contract
38+40 ETON AVENUE
LONDON NW3

drawing
PROPOSED SECOND FLOOR PLANS

number 562/L/33 | revision J

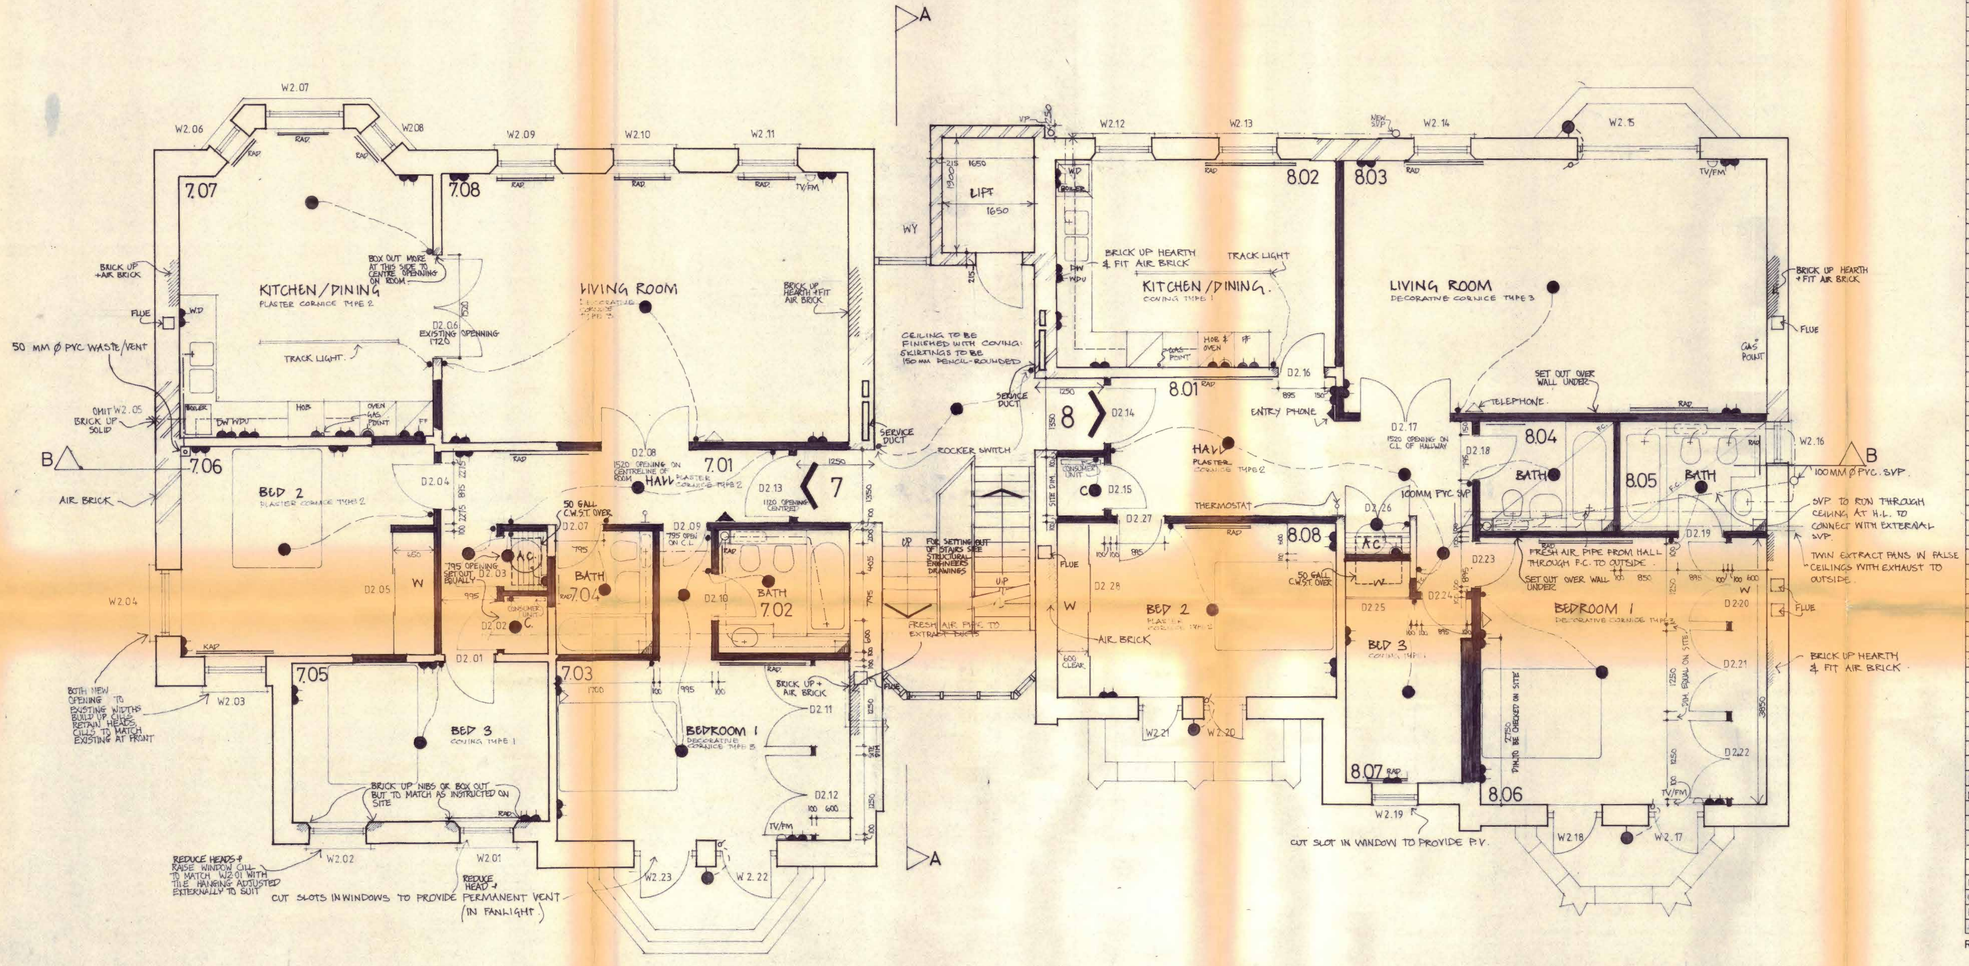
J. POSITION OF SVP ADJACENT TO WET SHAFT MOVED TO THE LEFT OF W2.14, + SOIL PIPE TO KITCHEN SINK CORRECTED, + VP ADDED. REAR CHIMNEY BREAST CUT BACK, NOTES + GAS POINT TO LIV ROOM REMOVED. POSITION OF THERMOSTAT CORRECTED, UNVENTED UNITS ADDED. 14/6/85
H. 9.7.85 SIZE OF SERVICE DUCTS CORRECTED, G.P.O. POINT ADDED.
G. 6.8.85 POSITION OF RISERS IN CENTRAL CORE STAIR AMENDED. BED1, RISE OF RADIATORS CORRECTED IN ACCORDANCE WITH SCHEDULE & POSITIONS OF BOILERS + SERVICE DUCTS ADDED.
F. NOTES + DIMS. ADDED + POSITION OF C.W.S.T SHOWN. 29-6-85
E. UPDATING OF KITCHEN LAYOUT. 19-6-85 NOTES ADDED, DIMENSIONS ADDED, NOTES REMOVED; BEDROOM 3 & RIGHT INTERNAL WALL THICKENED; POSITION OF FLUES ADDED. WINDOW W2.05 OMITTED + OPENINGS BLOCKED UP.
D 14.5.85 DIMENSIONS ADDED.
C 10.5.85 [illegible]
B 10.5.85 SERVICES SHOWN.
A 14.2.85 [illegible]
